CHAPTER 343, HRS Environmental Assessment/Determination Negative Declaration

C.Q. YEE HOP PROPERTY DEVELOPMENT

BUILDING DEMOLITION & PARKING CONSTRUCTION CHINATOWN, HONOLULU, HAWAII T.M.K. NO.: 1-7-02: 13, 14, 24, 44 & 50

Draft Environmental Assessment for Demolition of Existing Buildings and Construction of a Parking Lot

PROPOSED SITE PLAN SCALE: 1" = 50'-0"

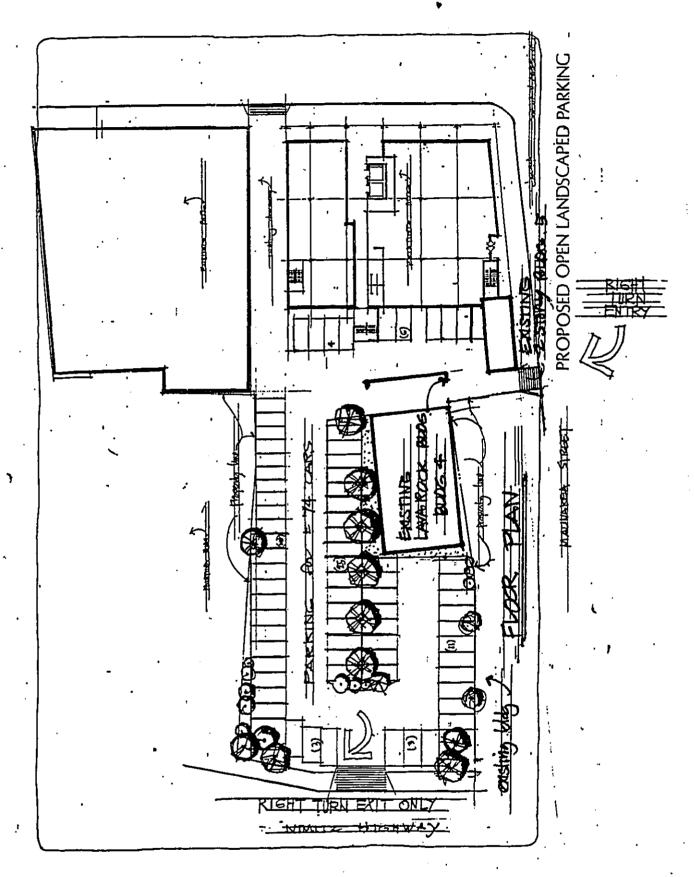
In addition, the above-mentioned guidelines discourage on-grade parking lots exposed to street frontages. They recommend that atgrade parking areas be placed behind commercial storefronts or false facades in order to preserve the continuity of the streetscape and create a pedestrian-oriented retail environment.

- 1. The Maunakea Street driveway should be widened if it is to accommodate two-way traffic.
- 2. Any landscaping in the vicinity of the driveway should be the type that will not obstruct visibility for vehicles and pedestrians.
- 3. Clear sight distances will be required for the existing driveway.
- 4. If the entrance is to be controlled by a card reader or security, it should be located as far away from the street as practical.
- 5. Construction plans, including the topography along Maunakea Street, should be submitted to our department for review as they become available.

- 1. The Maunakea Street driveway should be wide enough to accommodate two-way traffic.
- 2. The first two stalls at the entrance to Maunakea Street should be eliminated.
- 3. Any landscaping in the vicinity of the driveways should be the type that will not obstruct visibility for vehicles and pedestrians.
- 4. If the entrance is to be controlled by a card reader or security gate, it should be located as far from the street as practical to eliminate the potential for queuing on any public street.
- 5. Construction plans, including the topography along Maunakea Street, should be submitted to our department for review as they become available.

- 1. The Maunakea Street driveway is one way entry only.
- The existing driveway adjacent to the 2-story retail is too narrow to plant any landscaping.
- The existing building at the Maunakea entry will not cause any visual problems, since it is an entry only. The Nimitz Highway exit will be open & clear to meet necessary site distances.
- The control gate at the entry will be set back so that we will have approximately 3 car staging conditions.
- 5. All construction plans, including the topo will be submitted for review.
